## Vogtle Project

January 31, 1985

NRC DOCKET NUMBERS 50-424 and 50-425  
CONSTRUCTION PERMIT NUMBERS CPPR-108 AND CPPR-109  
VOGTLE ELECTRIC GENERATING PLANT - UNITS 1 AND 2  
DRAFT REVIEW COPY OF FSAR CHAPTER 13

PLANT ORGANIZATION  
FIGURE 13.1.2-1  
SHEET 1 OF 2

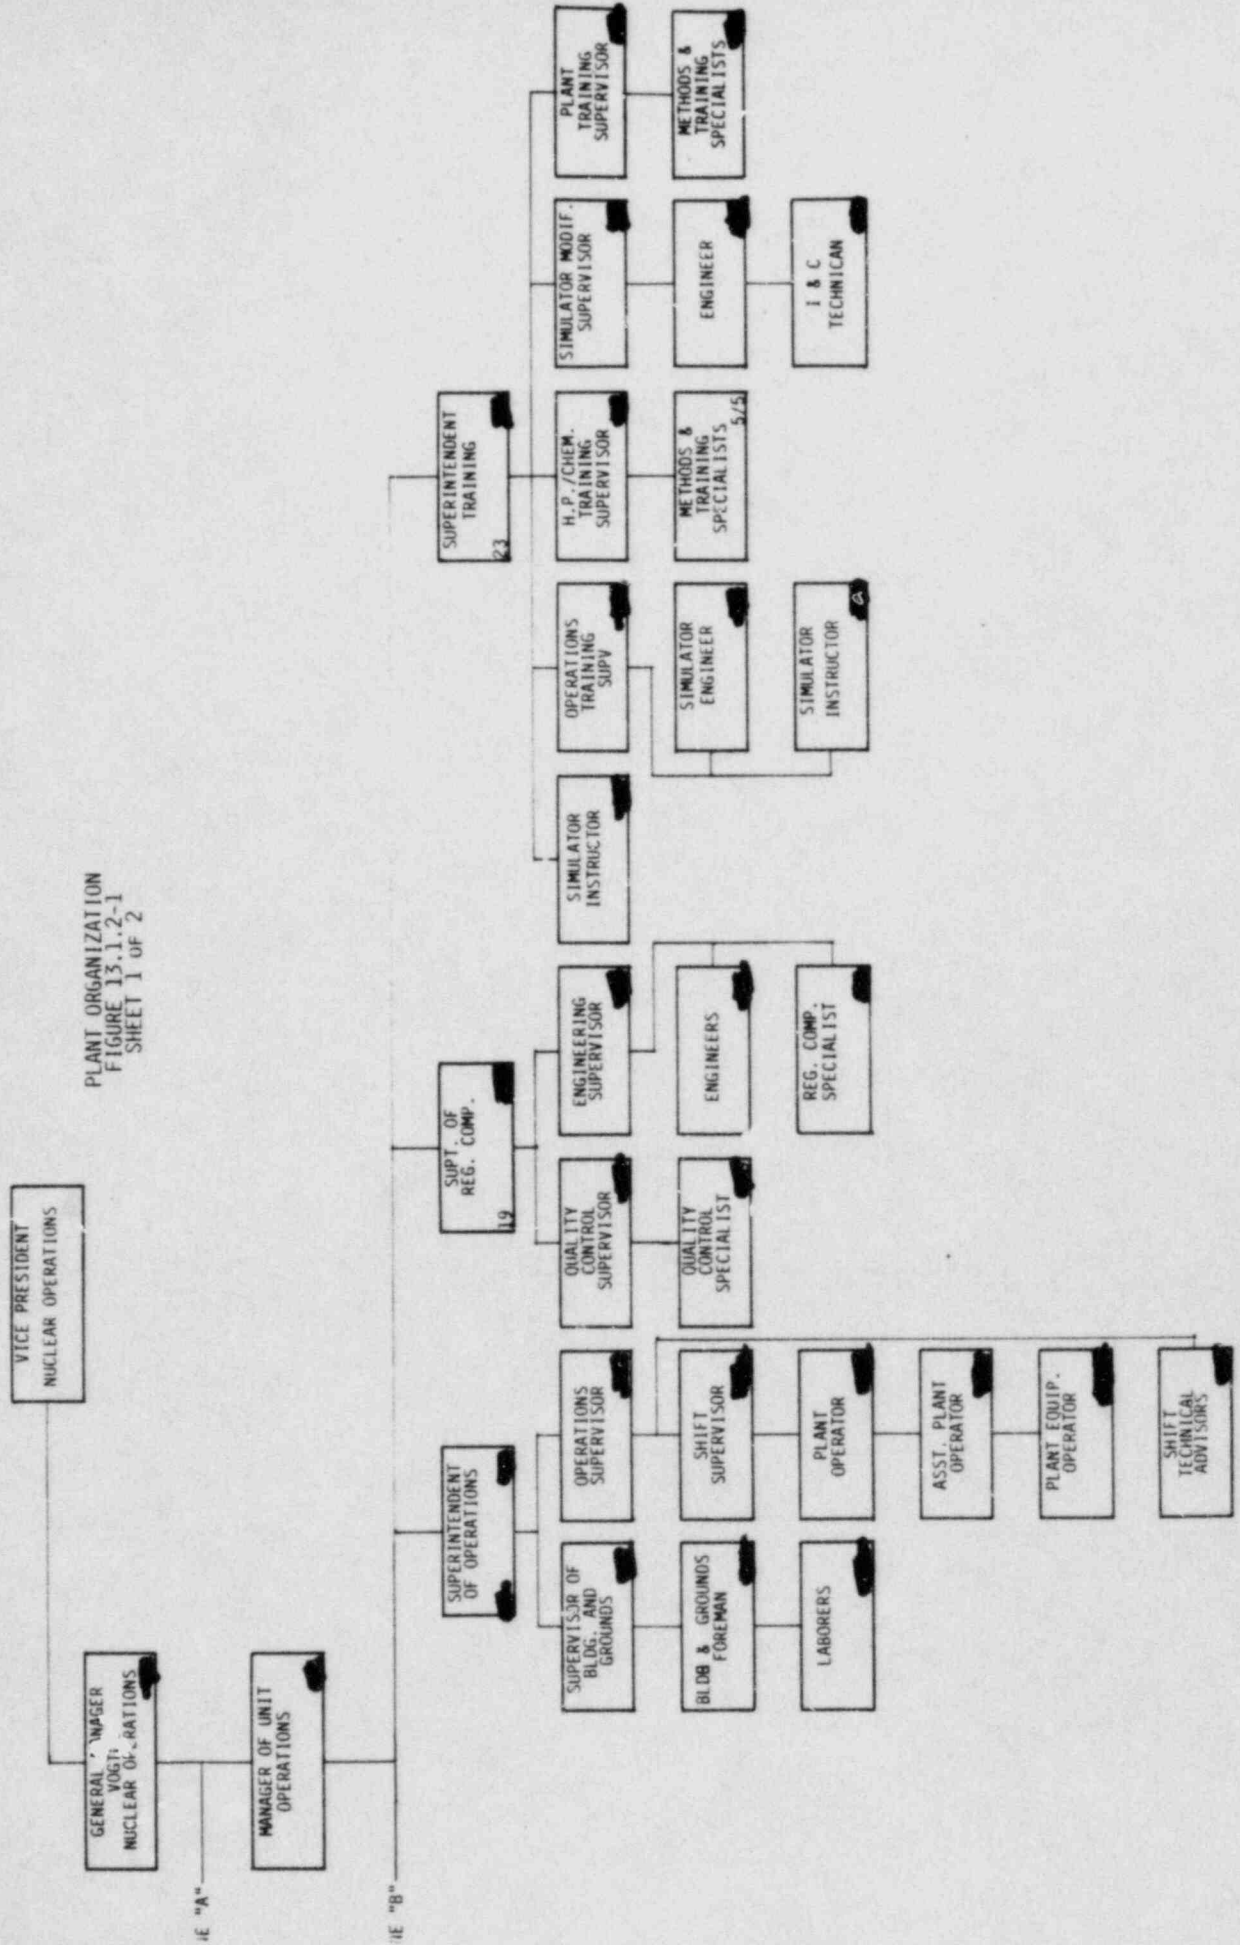
*RP*  
*lc* → *The structure of the preoperational and startup organization is shown on figure 13.1.2-2*  
REPORTING TO THE INITIAL TEST PROGRAM MANAGER DIRECTLY AND INDIRECTLY  
ARE THE FOLLOWING SELECTED POSITIONS:

FIGURE 13.2.1-2

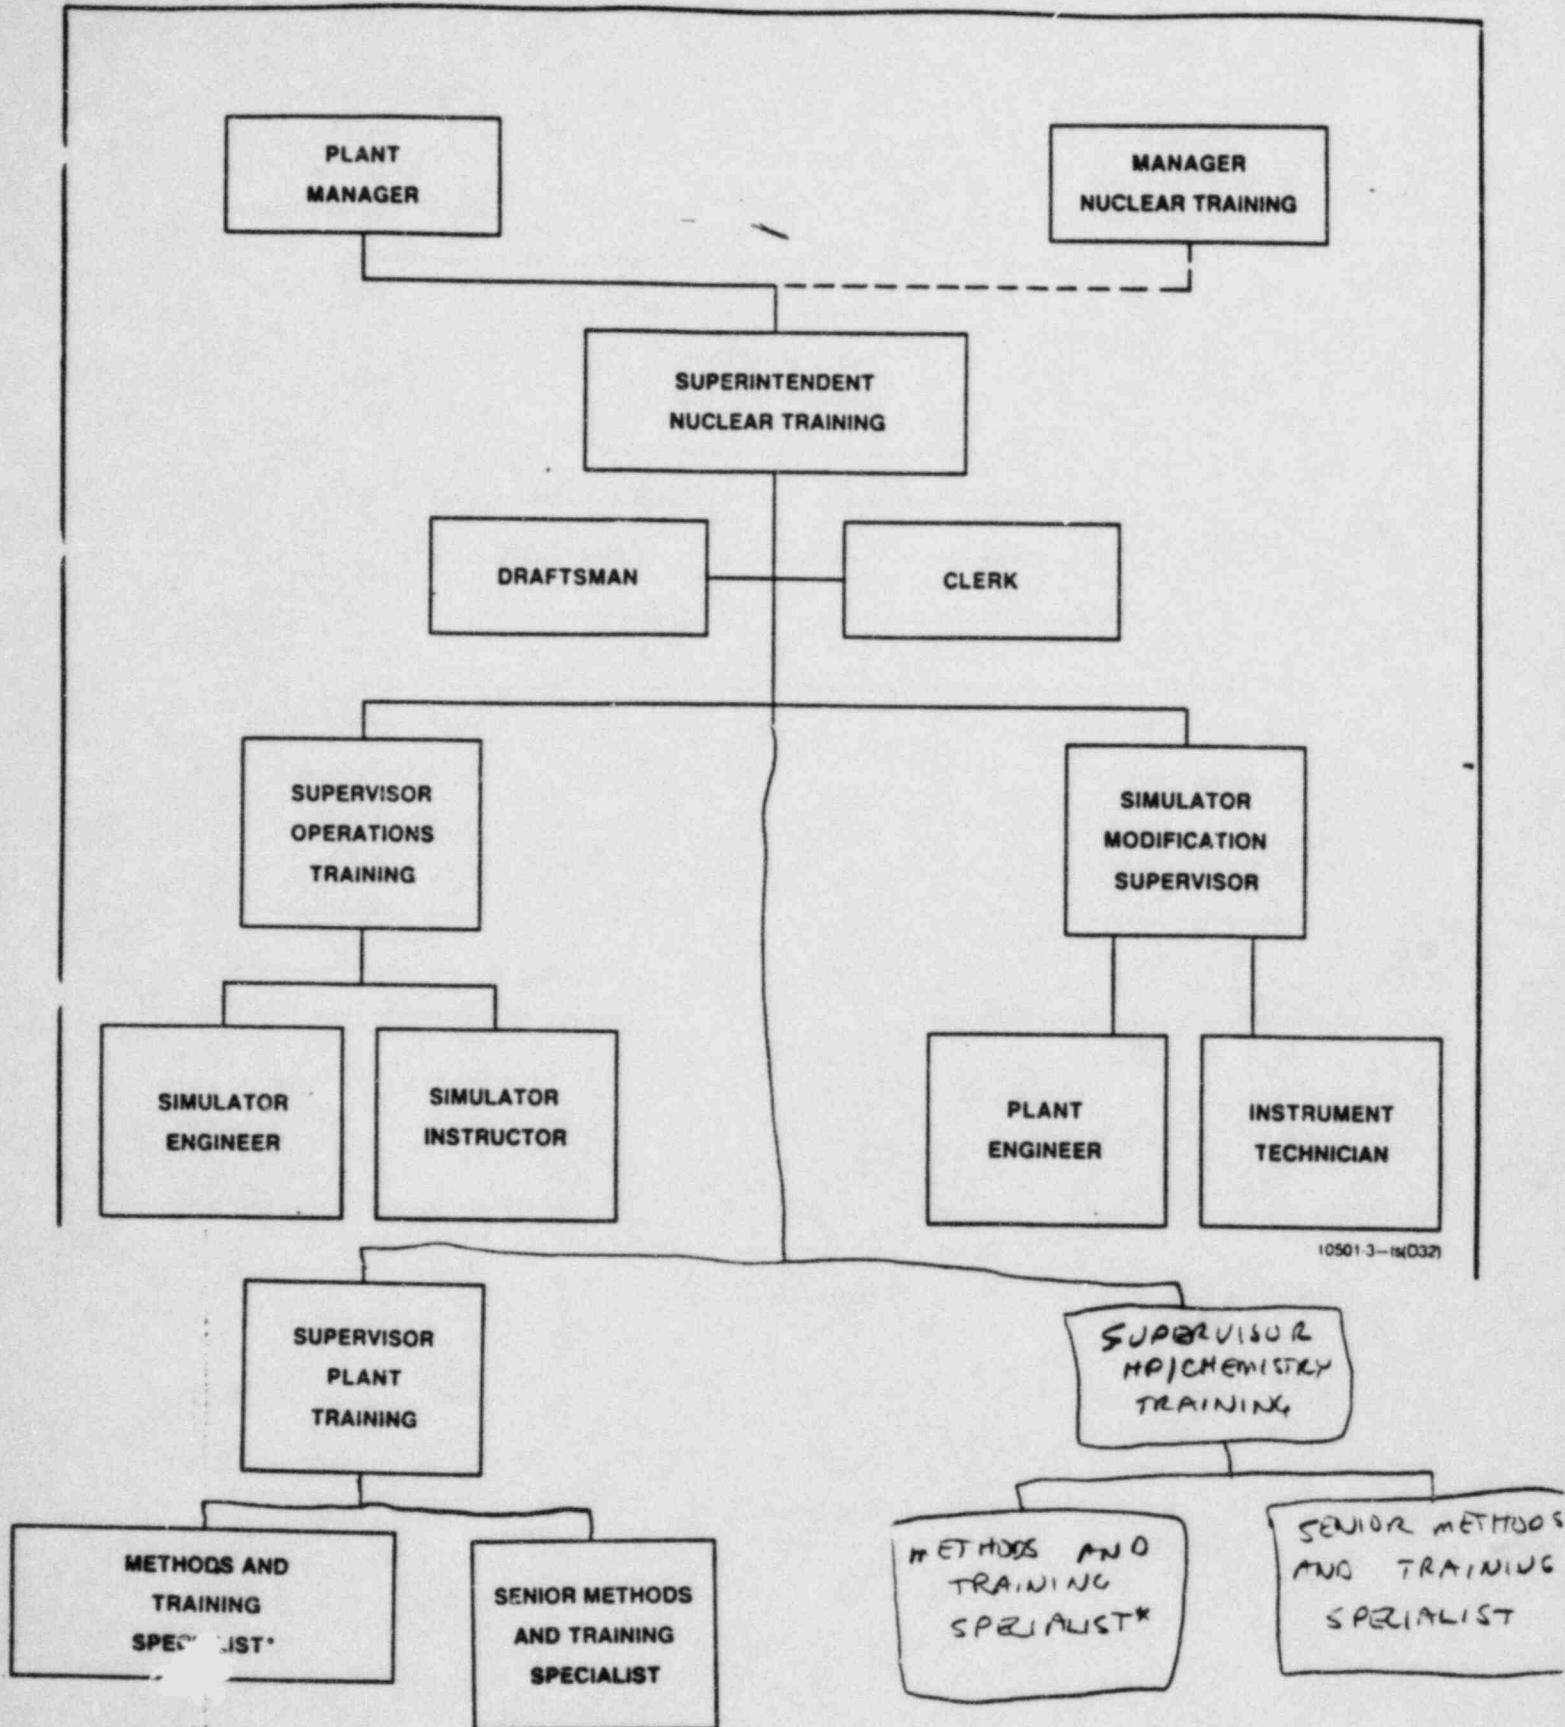
FSAR table 13.1.2-2 and FSAR figures 13.2.1-2 and 13.2.2- indicate the schedule for ~~licensed operator~~ SRC and RC training to meet the minimum shift staffing and other plant positions
